Commissioner Julia Levin, Presiding Member  
Vice Chair James D. Boyd, Associate Member  
Mr. Craig Hoffman, Project Manager  
Abengoa Mojave Solar Project (09-AFC-5)  
California Energy commission  
1516 Ninth Street  
Sacramento, CA 95814

**Re: Abengoa Mojave Solar Project (09-AFC-5): Written Response to Data  
Request Set 1B (nos. 1-86)**

#### **Item 67:**

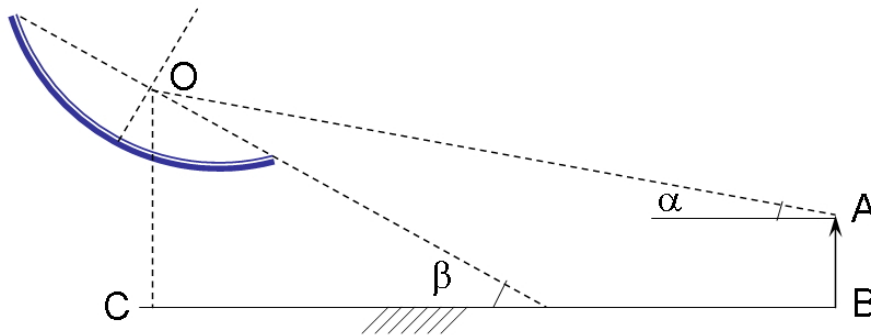
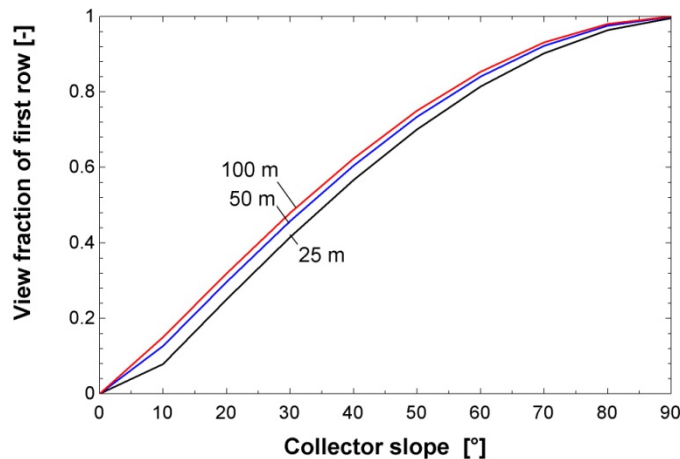
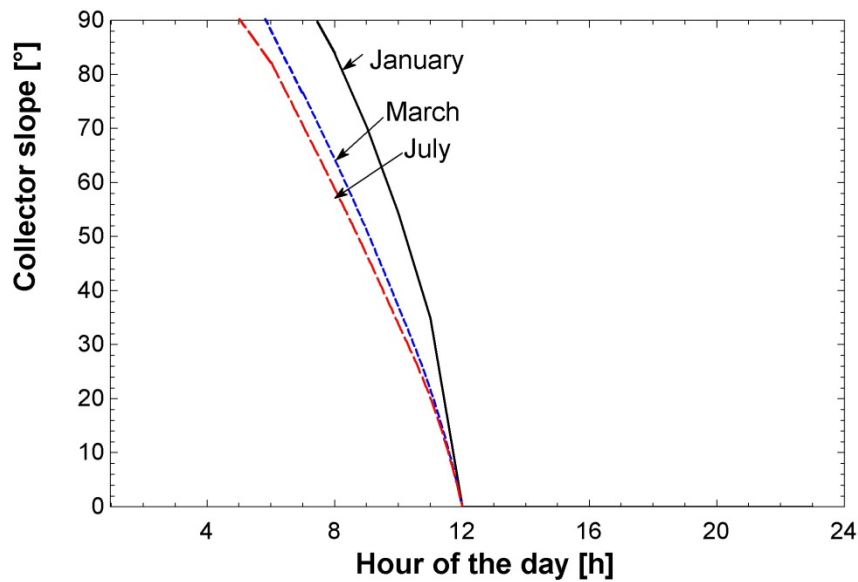
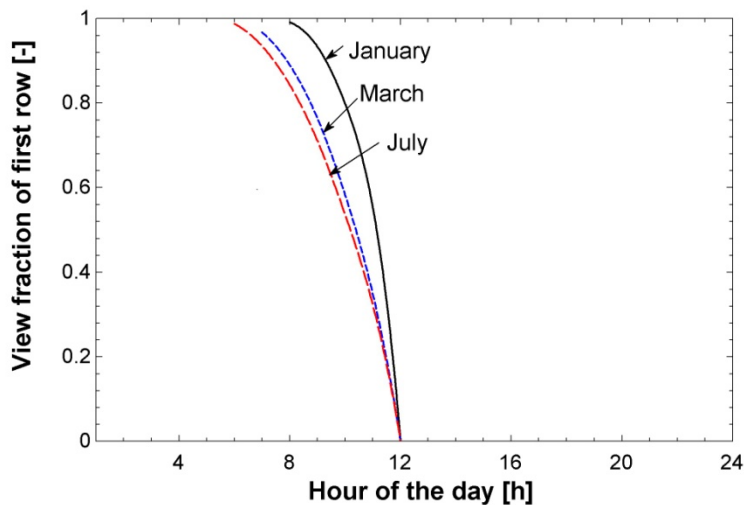
Please describe the hours in which the mirror surface of a trough could be visible to an off-site viewer on the ground, and the proportion of surface visible in the course of the day.

In order to answer this question, the following picture defines the basic geometry of an observer represented by the line AB, at a distance BC from a collector which is in a tilted position described by the slope angle  $\beta$ . The observer's view angle from the horizontal to the center of the collector (O) is described by the angle  $\alpha$ .

the value of  $90^\circ$ , but facing west. For a particular observer located on the east side of the collector, the mirror surface will be visible only from sunrise to noon.

An analysis was performed in order to evaluate the mirror surface visible to an observer at a distance BC from the collector. The following figure shows the mirror surface visible to an observer at different collector slope angles. Three distances from the collector were evaluated: 25m, 50m and 100m, which show very similar behavior. The vertical axis in this plot is presented as the non-dimensional visible surface area, calculated as the ratio between the visible area to the aperture of the collector.

The second step was to calculate the hourly collector slope for the entire year. The following figure shows the monthly average collector slope, for January, March and July, as function of hour of the day. For this plot, only the values of slope when the collector face east are plotted, indicating the slope for the time of the day in which some part of the mirror surface is visible. This plot shows how the sunrise is earlier in July than in January, as well as it shows a much faster movement of the collector during winter, going from a slope of  $90^\circ$  to zero in fewer hours than in July.

Finally, the two functions (the fraction of visible mirror surface as function of collector slope and the slope as function of hour of the day) were combined into a single figure. The following figure shows the fraction of the mirror surface visible to an observer at 100 meters from the collector, as function of hour of the day.

This plot indicates that an observer located on the east side of the collector field will see a fraction of the collector surface from sunrise to noon. However, this fraction drops very rapidly during the day. In July, the visible collector surface drops to 50% in 4 hours, while in January it drops to 50% in less than 3 hours.

**Figure 1. Illuminated HCE Pictured from Below**

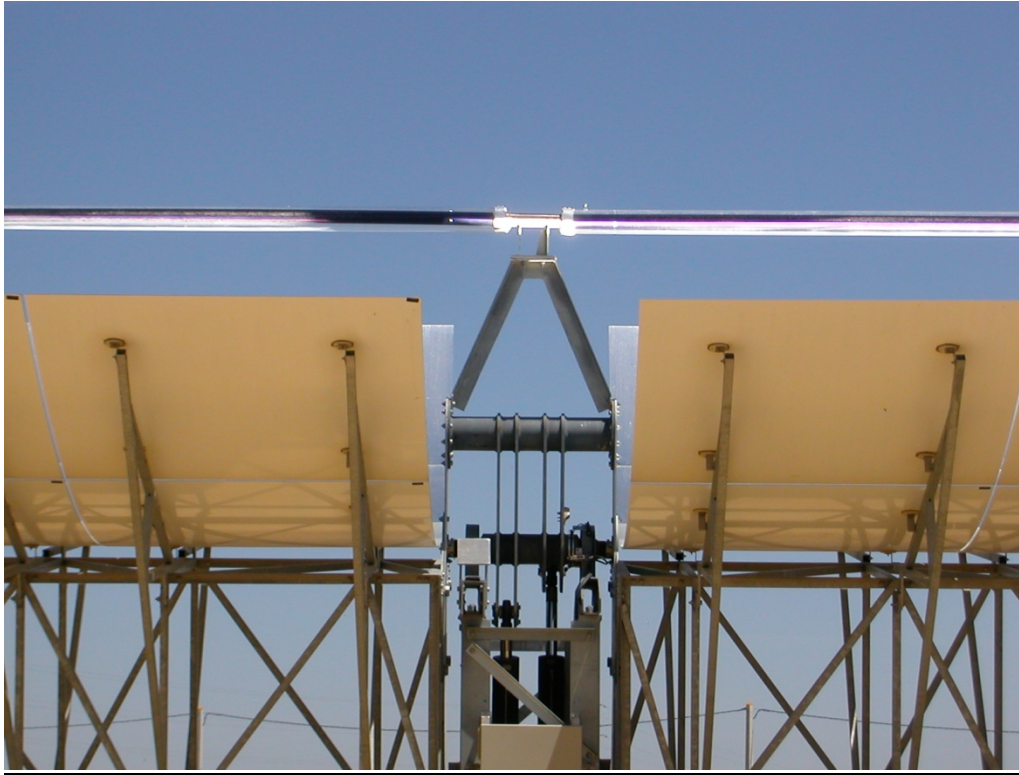
Please provide all available anecdotal information on glare effects of the Kramer Junction and existing Luz Solar Energy Generation System (SEGS) XI and XII power plants to the west and north of the project site, including photographs of off-site diffuse or spread glare, and images of the heated HCEs, as seen from public roads/viewpoints.

Pictures available to the Applicant and taken of the Applicant's project in Sevilla Spain showing with illuminated HCEs are included in Figure 1 and Figure 2 below.

**Item 71:****Information Required:**

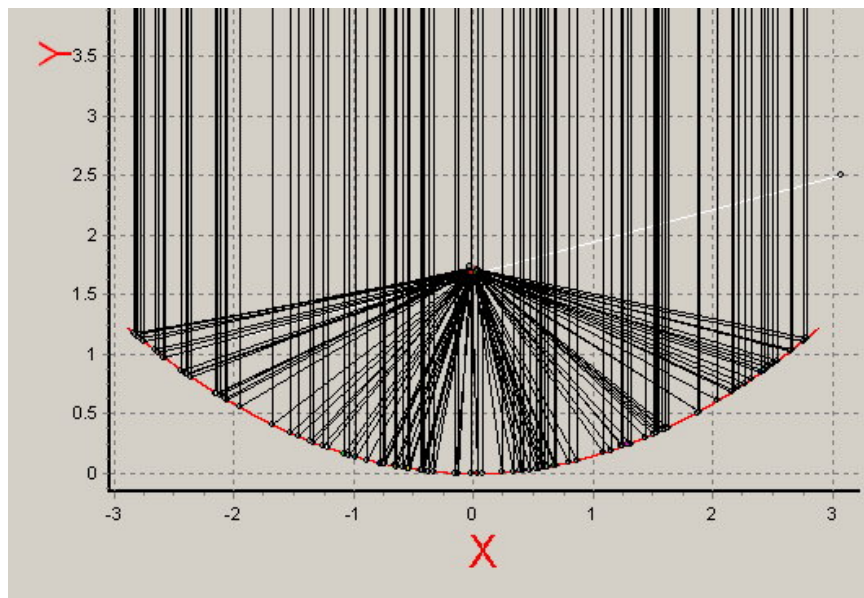
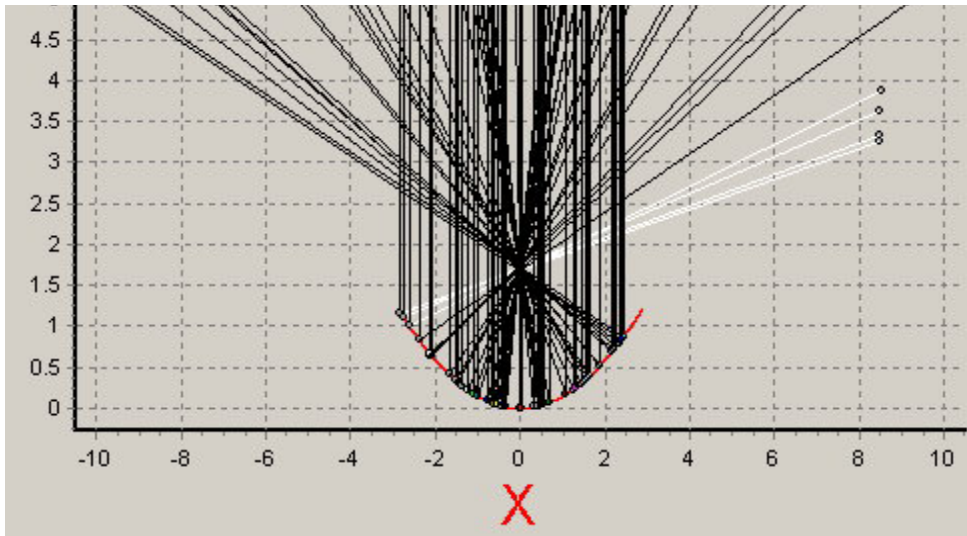
Please explain whether any portion of the directly reflected solar radiation could pass by the HCEs (the steel tube annulus) due to the total divergence factor of the reflectors.

- A. If so, how much?
- B. Is this amount sufficient to cause any potential retinal damage or flash blindness?
- C. Are there measures that would prevent such inadvertent off-site reflection (such as shielding of the HCEs, etc.)?

The following figure shows an example raytracing analysis of the collector. The high concentration of lines on the receiver and the few missed rays demonstrate the high optical accuracy of the collector.

A. Please refer to the answer provided for Data Request Item 70.

B. The Applicant is not qualified to make judgments better made by an ophthalmologist. Notwithstanding this, the Applicant expects that the answer is no. Only 3% of the energy that hits the mirror misses the receiver. Furthermore, once the radiation misses the focal point (i.e., the receiver), the radiation becomes more and more dispersed. For example, the following figure represents a raytracing analysis without the receiver. The vertical sun rays hit the mirrors and

are reflected towards the focal point. However, once that they pass the focal point, the distance between them grows as they leave the collector. This behavior indicates the behavior of the rays that miss the receiver.

C. There are no practical measures that would prevent such reflection. Any measure that would try to prevent this radiation would result in higher energy being missed by blocking incident radiation.
